Case Number ACP – 323957-25

Ballyfasy Wind Farm

Response to Submissions Report

MANOGATE LTD

Figure 2-1: Habitat loss at Turbine 7 (snapshot from EIAR habitat map 6-8 including T7 hardstand)

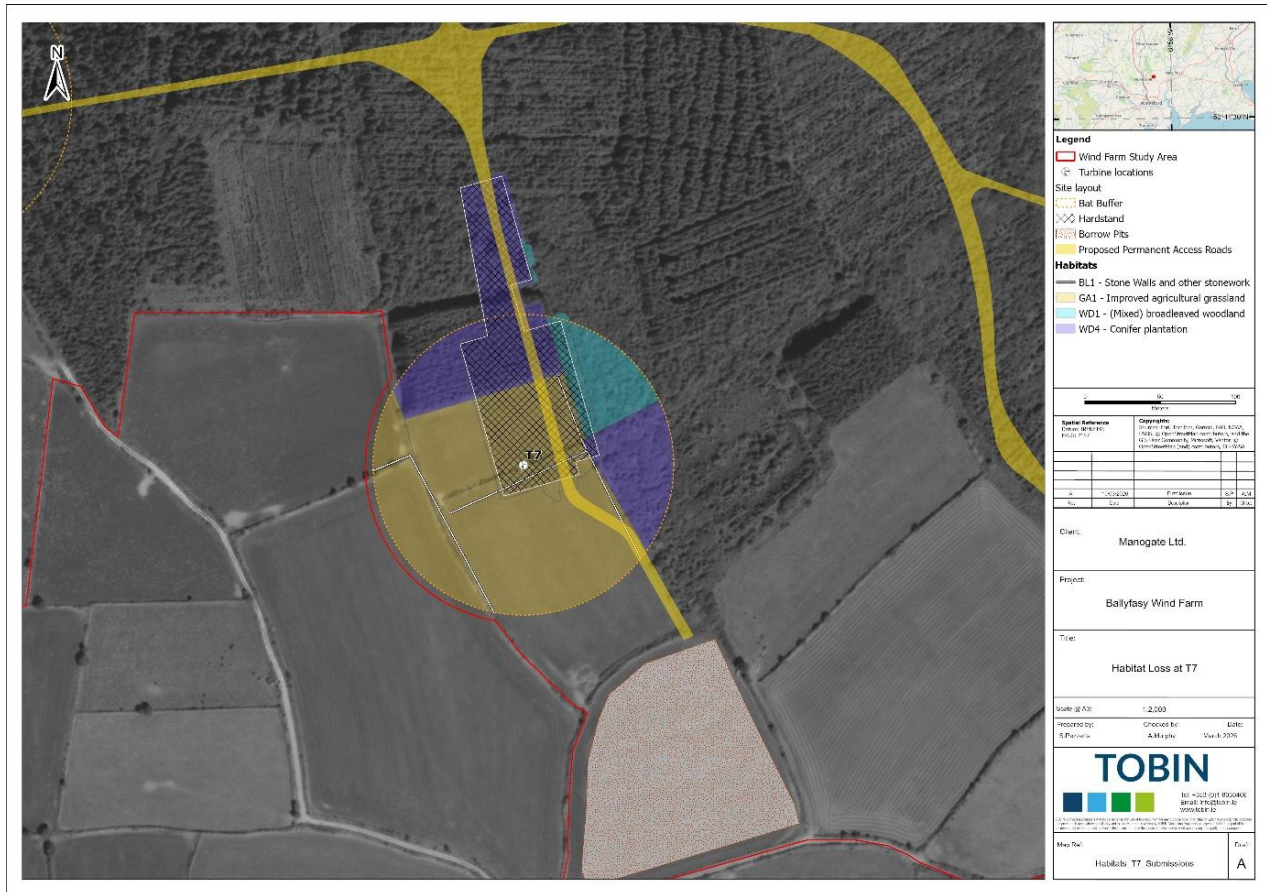
The DAU submission notes the habitat loss that will occur as a result of the proposed development and in particular queries the positioning of the turbine T7 hardstand in woodland habitat and overall loss of hedgerows and treelines. The DAU also expresses concern regarding the residual habitat loss and lack of replanting.

With regards to woodland habitat loss at Turbine 7, this turbine has been located within an agricultural grassland field, and hard-standing areas associated with this turbine will result in the removal of 0.12ha of mixed broadleaved woodland (see Figure 2-1 herein). The bat buffer area for this turbine will result in the removal of a further 0.21ha of this woodland. In total, 0.32ha of mixed broadleaved woodland will be removed i.e. approximately 15% of the overall extent of this habitat onsite.

Enhancement measures outlined in EIAR Chapter 6 (Biodiversity) notes that there will be 2.39ha of compensatory woodland planting implemented as part of the proposed project, in the locations of the compounds. These are located approximately 530 m and 870 m away from the area of proposed woodland loss at Turbine 7 and will result in an approximate 99.9% net gain of this habitat onsite. Chapter 6 (Biodiversity) of the EIAR concludes that following the mitigation and enhancement measures proposed, the proposed project will not result in any significant residual effects on mixed broadleaved woodland habitat.

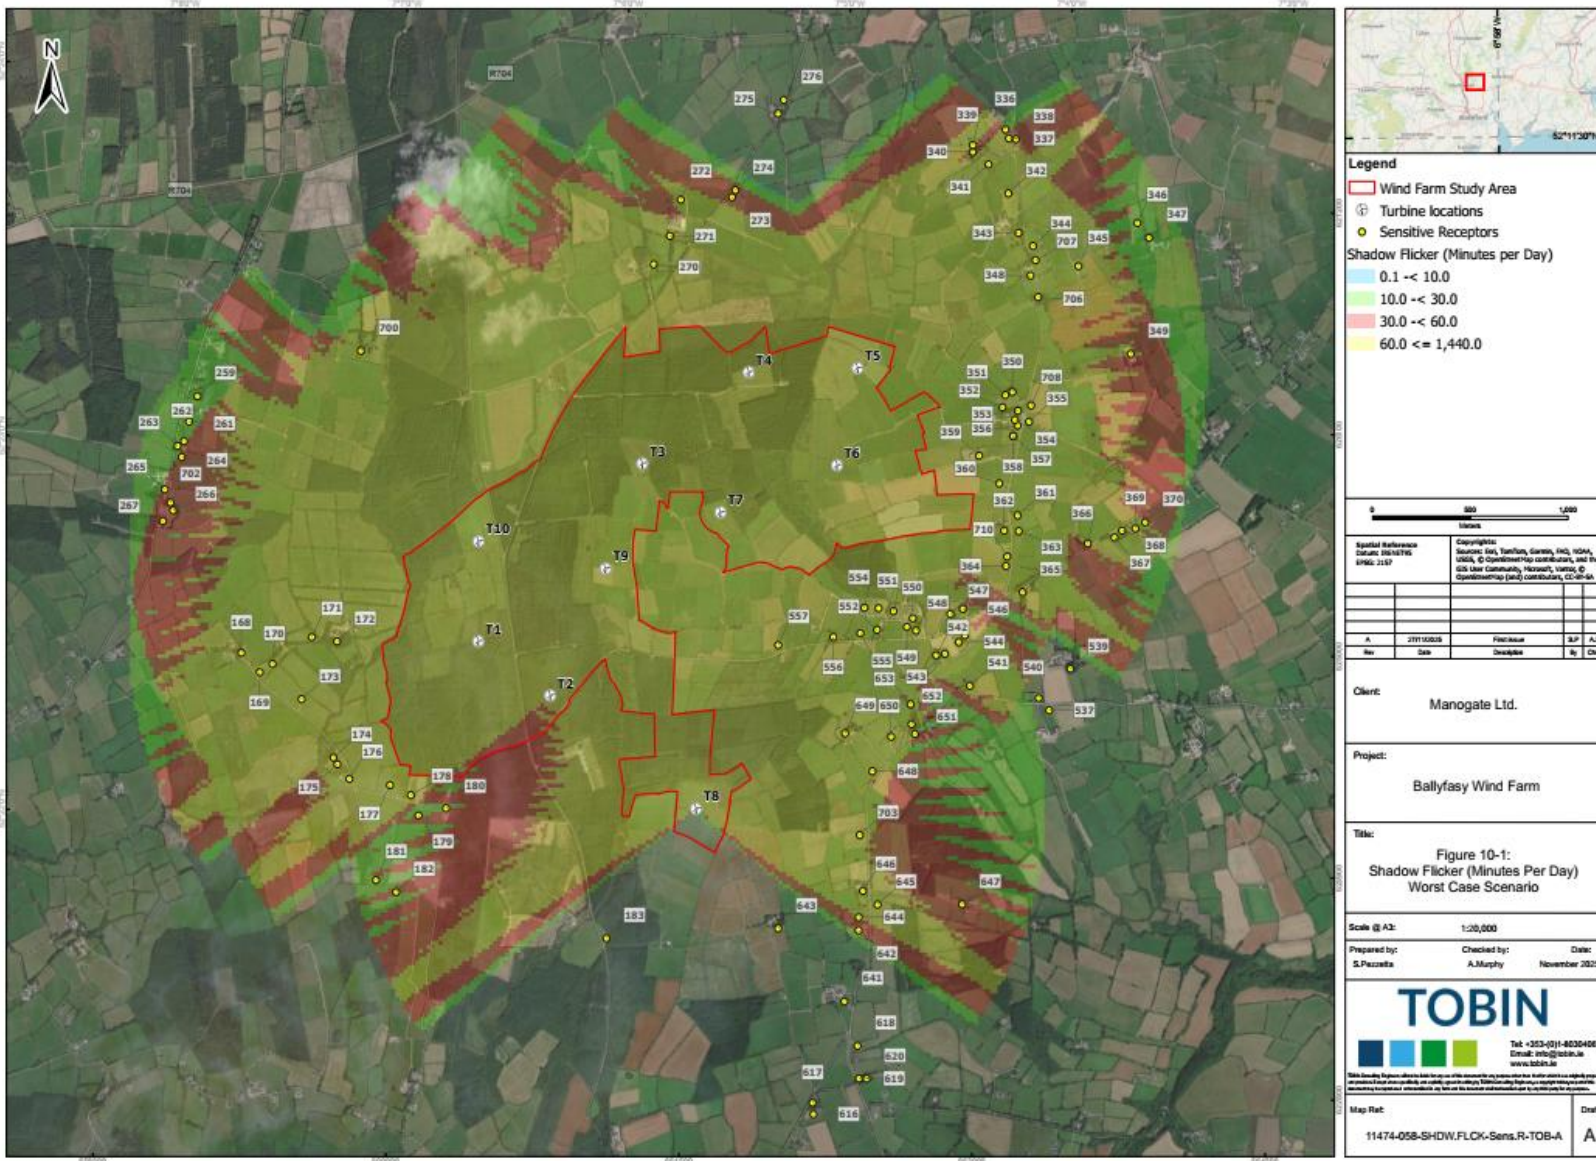
Several submissions raised concerns surrounding the potential shadow flicker impacts on the local national school, Ballyfacey National School. EIAR Figure 10-1 included with Chapter 10 (Shadow Flicker) (and presented overleaf) displays Ballyfacey National School as receptor 540. Ballyfacey National School is outside the predicted shadow flicker area.
